Work Order ID 140364

Item Name: Quick Release Heli-Utility-Basket™ Long, HD Lid, Spacepod™/Squirrel Cheek Comp.

DART SERVICE INSTRUCTION

**TO AMEND INSTALLATION INSTRUCTIONS D350-607-3 Rev.D,
INSTALLATION INSTRUCTIONS D350-607-4 Rev. C AND
INSTRUCTIONS FOR CONTINUED AIRWORTHINESS ICA-D350-607 REV. 6**
REF TCCA STC: SH94-14
REF FAA STC: SR00213NY
REF EASA STC: EASA.10016996
REF BRAZILIAN STC: 2007S03-03/-04/-05/-06

FIGURE 1: INSTALLATION OF D4775-041 FWD STRUT

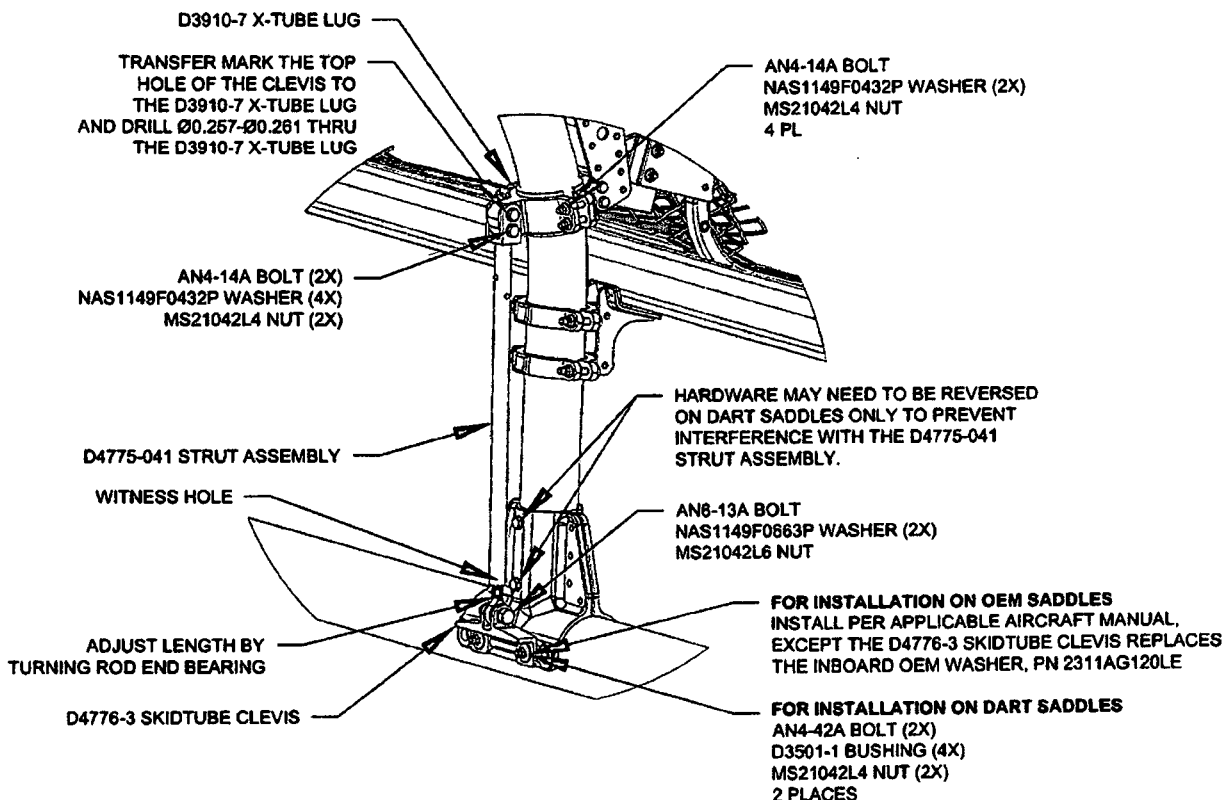
- 3.1 Substitute the Forward Lower D3910-5 X-Tube Lug with the D3910-7 X-Tube Lug as shown in Figure 1.
- 3.2 Install the forward D4775-041 Strut Assembly. Transfer mark from the upper hole on the clevis of the D4775-041 Strut Assembly to the D3910-7 X-tube Lug and drill thru the lug $\varnothing 0.257$ - $\varnothing 0.261$ as shown in Figure 1. Touch up chemical conversion coating per MIL-DTL-5541. Check the witness holes located at the bottom end of the D4775-041 Strut Assemblies to ensure that the thread from the rod end extends past the witness hole.
Torque MS21042L4/-4 nuts to 50-70 in-lbs (5.7-7.9 N-m). Torque MS21042L6/-6 nuts to 160-190 in-lbs (18.1-21.5 N-m).
- 3.3 Complete the installation in accordance with Installation Instructions D350-607-3 Rev. D or D350-607-4 Rev. C.
